**PLANNING & DEVELOPMENT**  
**CITY OF NEWARK**

January 27, 2020

The City of Newark's Subdivision Advisory Committee has reviewed the subdivision plan for Twin Lakes Boulevard dated May 8, 2019. (PR#19-06-02) We have the following comments:

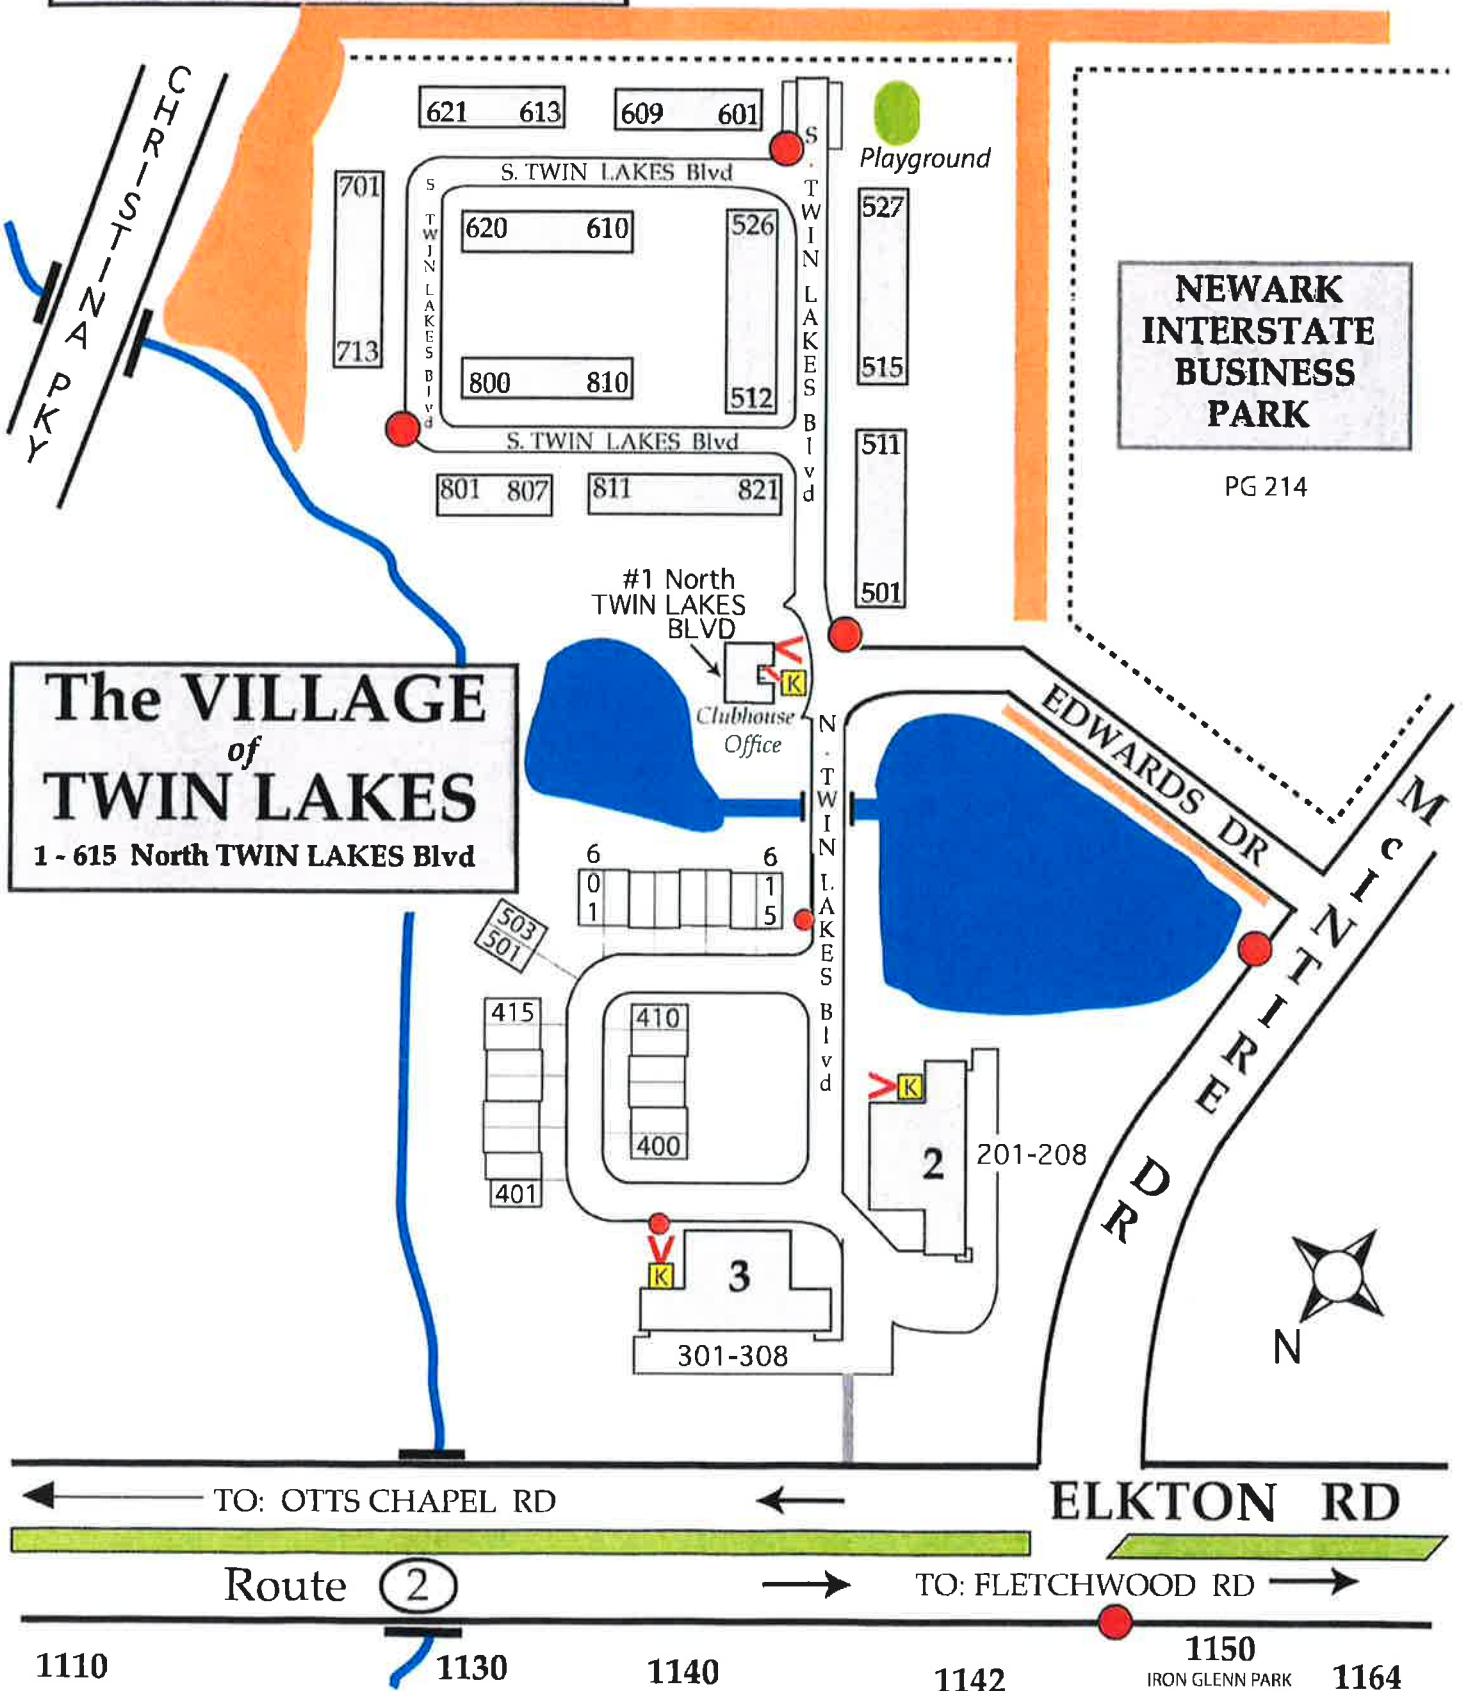
1. Plan should reflect addresses provided by police. (see attached)
